Subject: Dunn Field - Off Depot Air Sparge-Soil Vapor Extraction System Annual Operations Report, Year 4, Defense Depot Memphis, Tennessee, Revision 0 (March 2014): EPA Comments

**Responses to Comments from  
U.S. Environmental Protection Agency (EPA) Region 4  
Annual Long-Term Monitoring Report – 2013  
Defense Depot Memphis, Tennessee  
Revision 0, February 2014  
Memphis, Shelby County  
U.S. EPA ID Number TN4210020570**

**SITE MANAGEMENT PLAN, FIGURE 13**

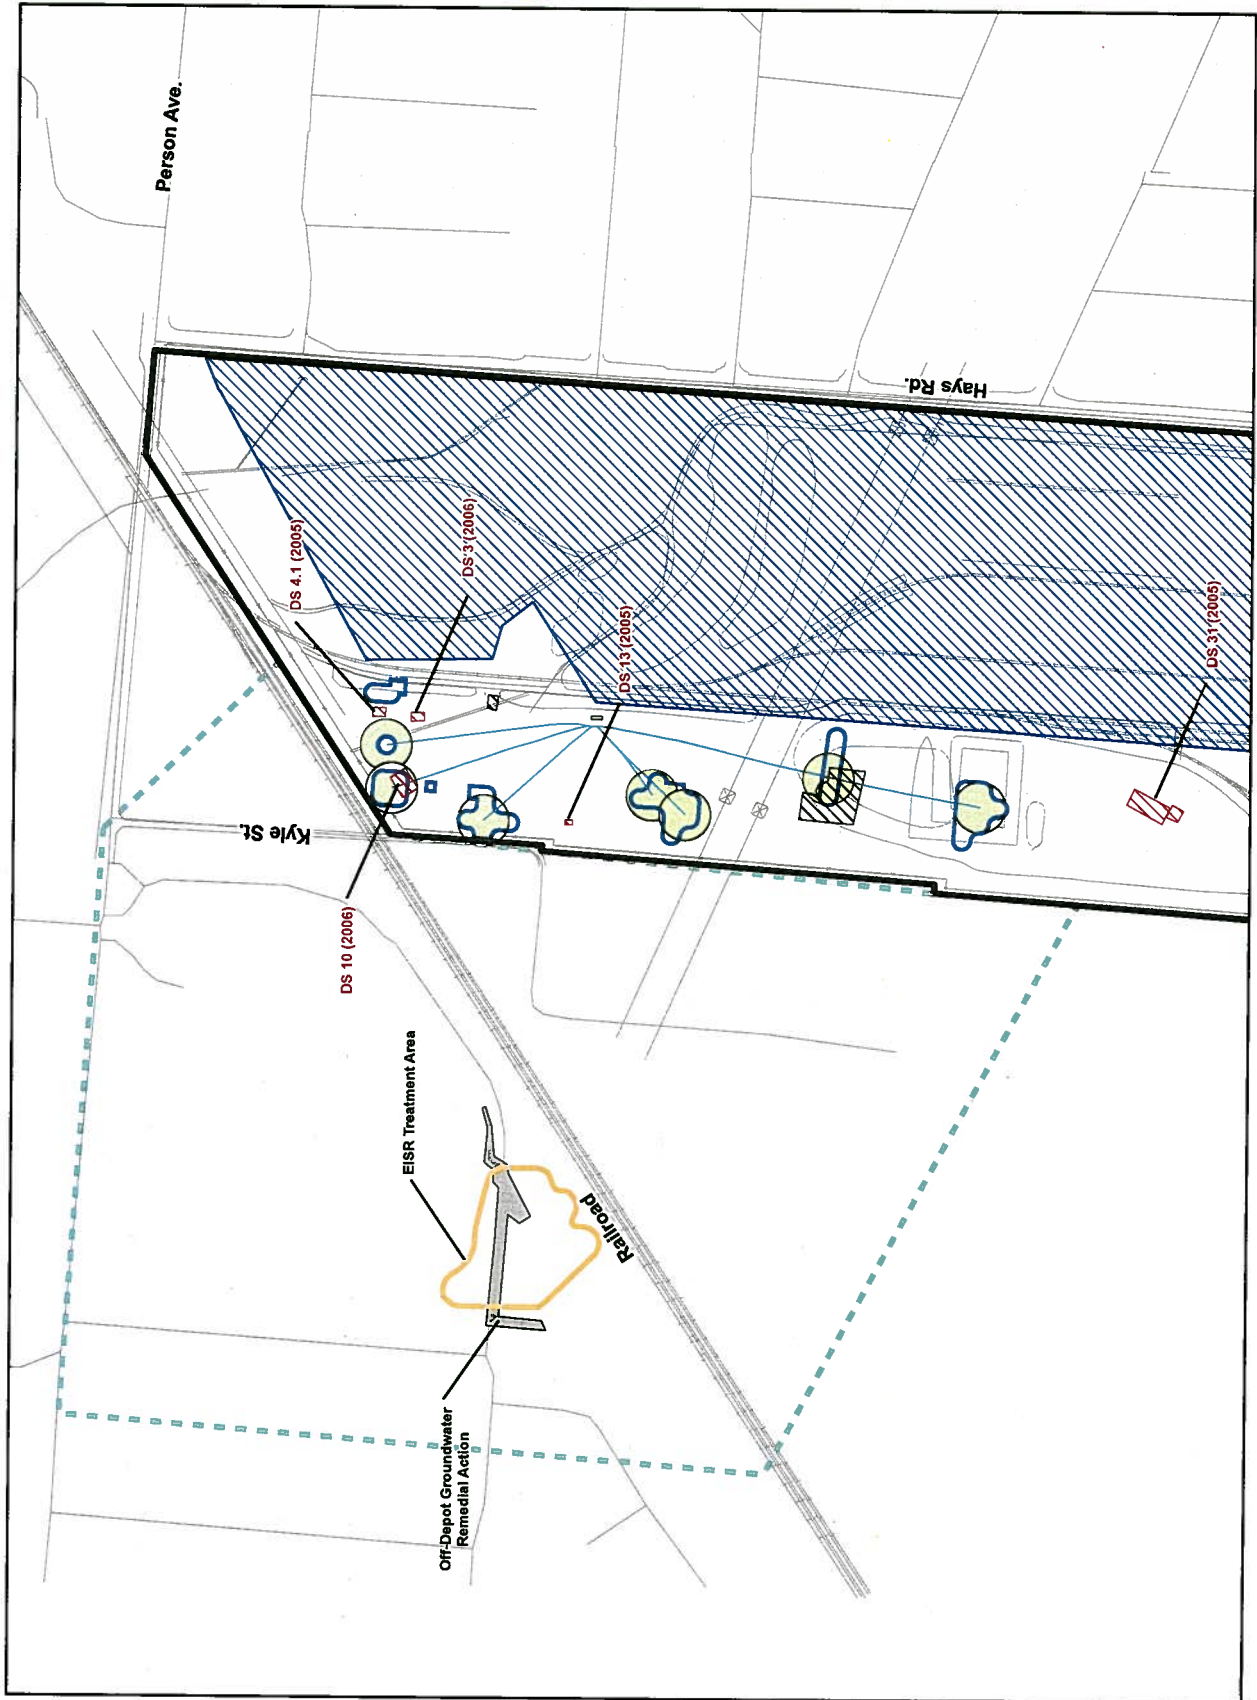
2. In addition to the contaminant concentrations at MW-159, the schedule for the DF groundwater remedial action appears to be impacted by imminent co-mingling of the inbound off-site plume

(originating northeast of Dunn Field in the general vicinity of the railroad right of way/Mclean Road/Persons Road area) with the central plume at DF. PCE and TCE contamination migrating in from the northeast has contaminated the fluvial aquifer underlying DF and is migrating westerly toward the general area of the AS/SVE system. The 2013 LTM Report notes (page 4-7) that the increase in contamination in MW-03 in the northwest corner of DF is attributed to the northeast off-site plume.

Army Response: While groundwater contamination does migrate on to the northeast corner of DF from an off-site source, there is little apparent co-mingling of contaminants. The contaminant source areas for the plumes originating on DF are located west of the north-south access road. See: *Enclosure 1, Site Management Plan, Figure 13 – Dunn Field Disposal Sites, Source Areas and Off-Depot Groundwater Remedial Actions* (attached).
